RECORD OF DECISION

HANFORD 200 AREA

200-CW-5 AND 200-PW-1, 200-PW-3, AND 200-PW-6

September 2011

Figure A-1: Visualization of the plutonium underneath the 216-Z-1, Z-2, Z-3 Cribs and Z-1A Tile Field viewed from the west.

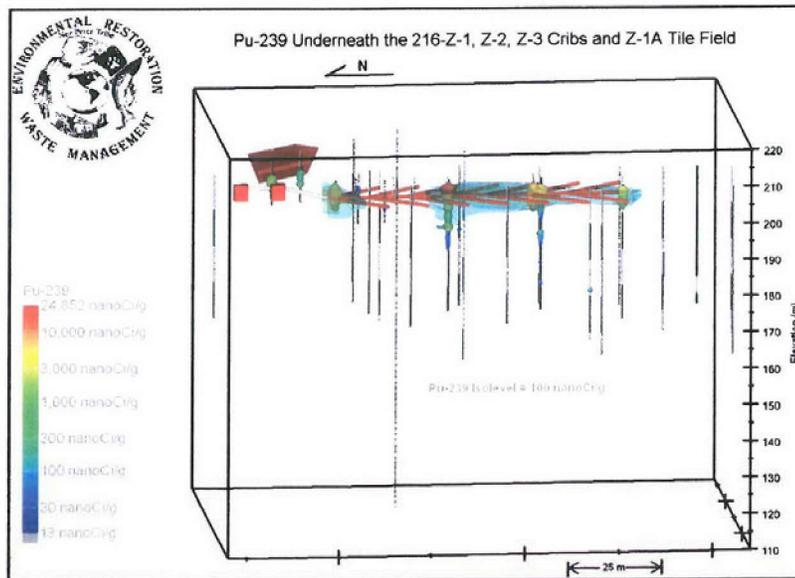
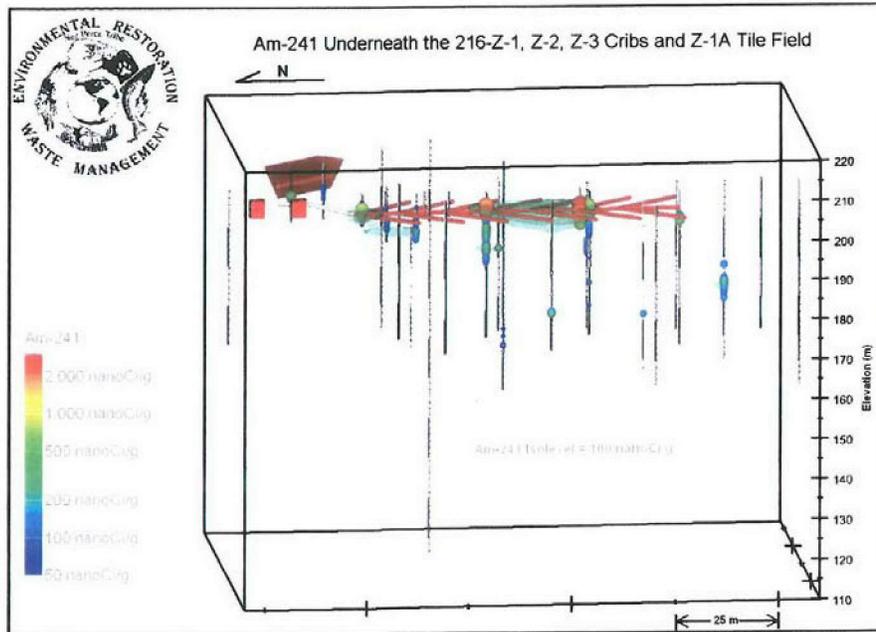
We believe that there was substantially more plutonium released at the 216-Z-1A Crib and tile field than has been reported. The Feasibility Study and RHO-SA-131 indicate that 57 kg of plutonium and 1 kg of Am-241 were released at this site. Based on our kriging of the area that encompasses only the B and C sections of the 216-Z-1A tile field, we estimate that the vadose zone contains 71 kg of plutonium (Figure A-1). RHO-SA-113 reported that a total of 27.4 kg of plutonium was discharged in the “B” and “C” sections. It is worthy of note that our kriging estimate for Am-241 for the whole tile field is approximately 0.5 kg (Figure A-2).

We recommend soil excavation to a maximum depth of 55 ft below ground surface (bgs) which should remove all actinides with activities greater than 100 nanoCi/g. After treatment to reduce volume, these actinides should be disposed at WIPP.

Figure A-4: Visualization of the americium-241 underneath the 216-Z-9 Trench viewed from the southeast.

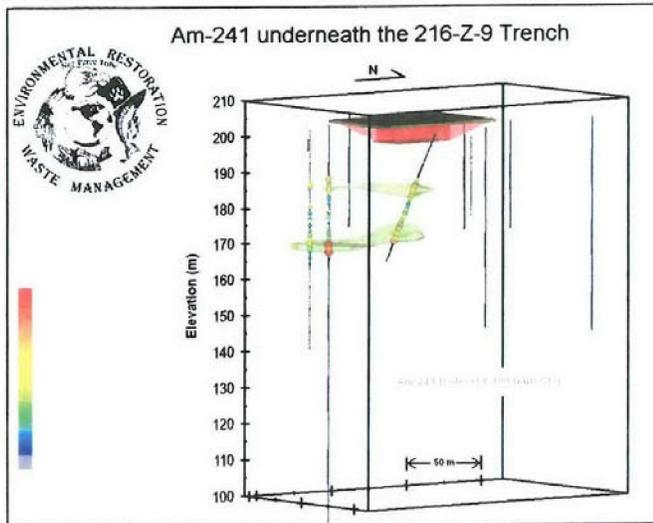
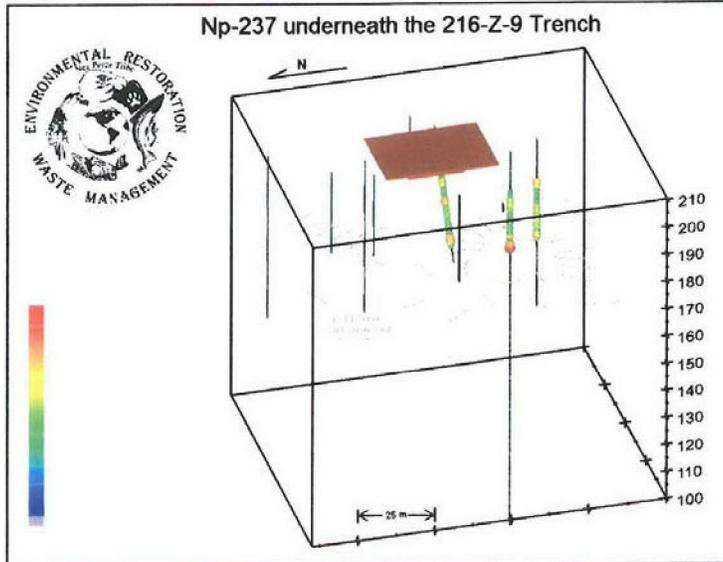
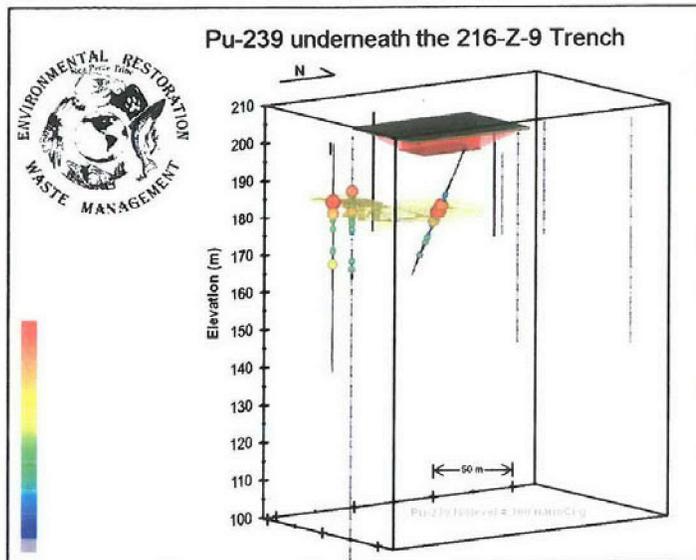
Carbon tetrachloride dense non-aqueous phase liquid (DNAPL) is likely present in the aquifer below 216-Z-9 trench. 216-Z-9 site modeling shows between 0 and 135,000 kg of carbon tetrachloride DNAPL in the aquifer below 216-Z-9 in 1993. Although this range is large it is considered valid by the EM-22 Remediation System Evaluation of the 200-ZP-1/PW-1 groundwater pump and treat system, Review Report: Feasibility Study Strategies and Remedial System Performance Improvement for the 200-ZP-1/PW-1 Operable Units at Hanford. The upper end of the large range is supported by inclusion of all surfactant like chemical components (DBBP and TBP) that were disposed with carbon tetrachloride in the Z complex. These additives increase the initial infiltration rate in the soil/trench bottom and reduce lateral spreading once in the vadose zone (Nellis, S.R. et al. 2009).

In addition, the rapid evaporation (20-80%) of the large amount of carbon tetrachloride suggested in DOE/RL-2007-22 is not computed correctly due to the lack of consideration of accelerated organic infiltration and by the incorrect assumption that the heavier carbon tetrachloride phase would float on the lighter water phase in the trench allowing more evaporation. The vast majority of the prompt carbon tetrachloride evaporation losses are minimized due to the DBBP and TBP components of the process discharges since these components enhance the organic phase's ability to wet water saturated soil.

Figure A-7: Visualization of the plutonium-239 underneath the 216-Z-12 Crib viewed from the west.

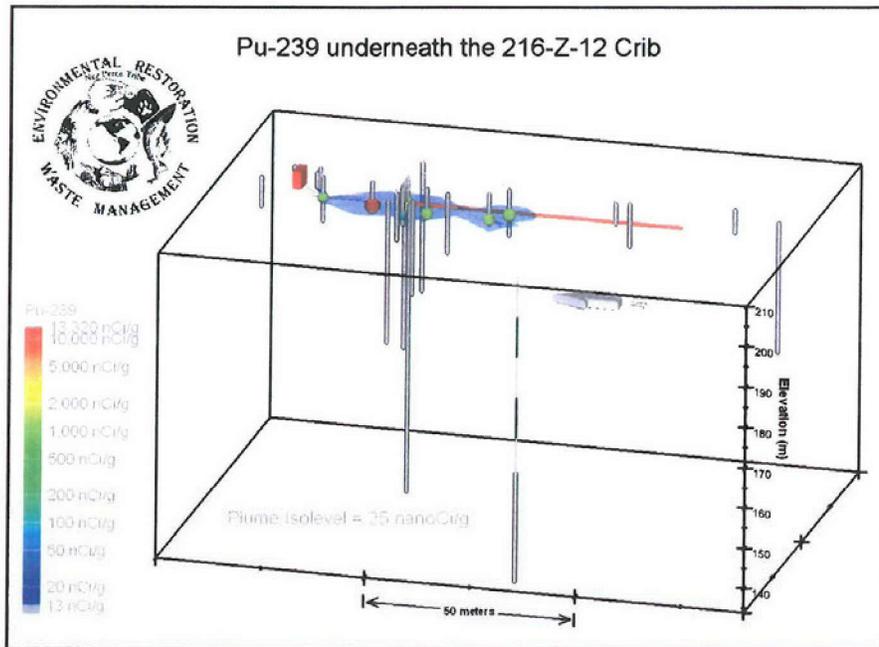
Unlike other Z waste sites, the plutonium-239 (activities greater than 25 nanoCi/g) underneath the 216-Z-12 Crib appears to be located within 10 ft of the distribution pipe (Figure A-7). The distribution of plutonium underneath the crib supports DOE's contention that in some cases plutonium is relatively immobile since this crib released more than 74 million gallons of waste to the vadose zone.

The assertion that 100% of the plutonium with activities greater than 100 pCi/g underneath the 216-Z-12 Crib is within 24 ft of the surface, on page 5-19 (Figure 5-5) of the Feasibility Study, is incorrect. Logging results from borehole 299-W18-181 (Figure A-8) indicate that plutonium-239 at activities of 100 nanoCi/g has reached 32 ft bgs (35 ft log depth). Thus, the cost of the remove, treat and dispose options 3D and 3E need to be recalculated to account for the plutonium below 24 ft bgs.

Figure A-9: Logging results for borehole 299-W18-162 from HGLP-LDR-211, Rev. 0

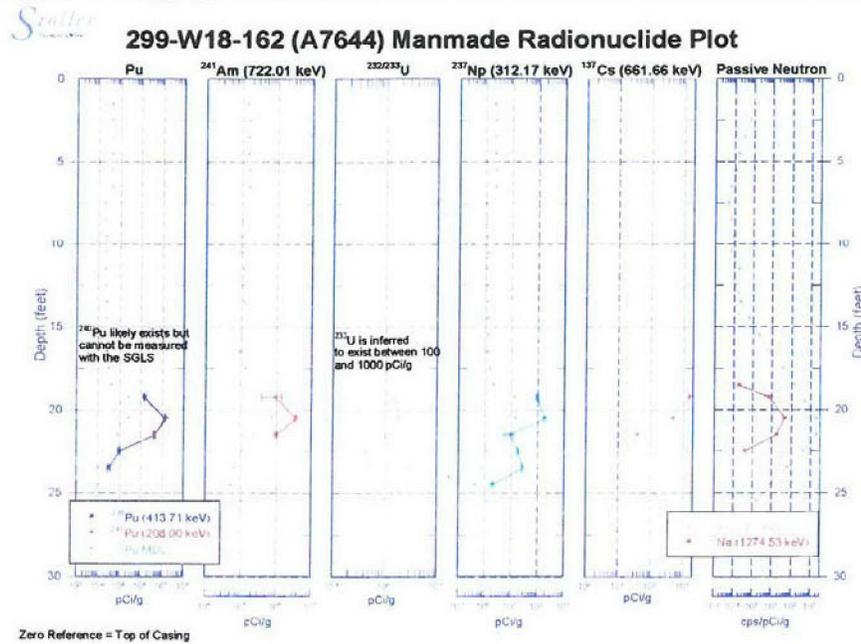
Logging results at the 299-W18-162 borehole (Figure A-9), which is located near the waste distribution pipe, indicate neutron count rates greater than 1,000 per second at 21 ft log depth. Neutrons have a relatively high relative biological effectiveness, and are roughly ten times more effective at causing cancers compared to photon or beta radiation of equivalent radiation exposure. The risk scenarios should include a section on neutron and neutron-gamma ray activation exposure before a final remedy is selected.

Figure A-10: Elevated gamma radiation isopach map of the 216-Z-18 Crib from DOE/RL-91-58.

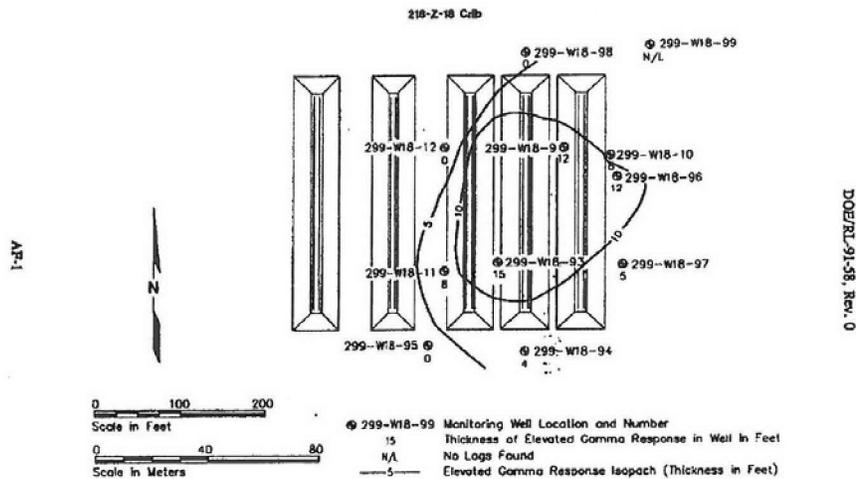
The distribution of actinides underneath the 216-Z-18 Crib needs additional characterization. Over one million gallons of waste was released at this crib, which drove actinides deep into the vadose zone and to the south and east beyond the footprint of the 216-Z-18 Crib (Figure A-10). In addition to boreholes 299-W18-9 and -10, which were reported in the Feasibility Study (p. 2-59), boreholes 299-W18-11, -93, -94, and -96 detected radiation above background as shown in Figure A-9 (DOE/RL-91-58).

Pending the outcome of additional characterization, we recommend soil excavation to a maximum depth of 61 ft bgs, which should remove all actinides with activities greater than 100 nanoCi/g. After treatment to reduce volume, these actinides should be disposed at WIPP.
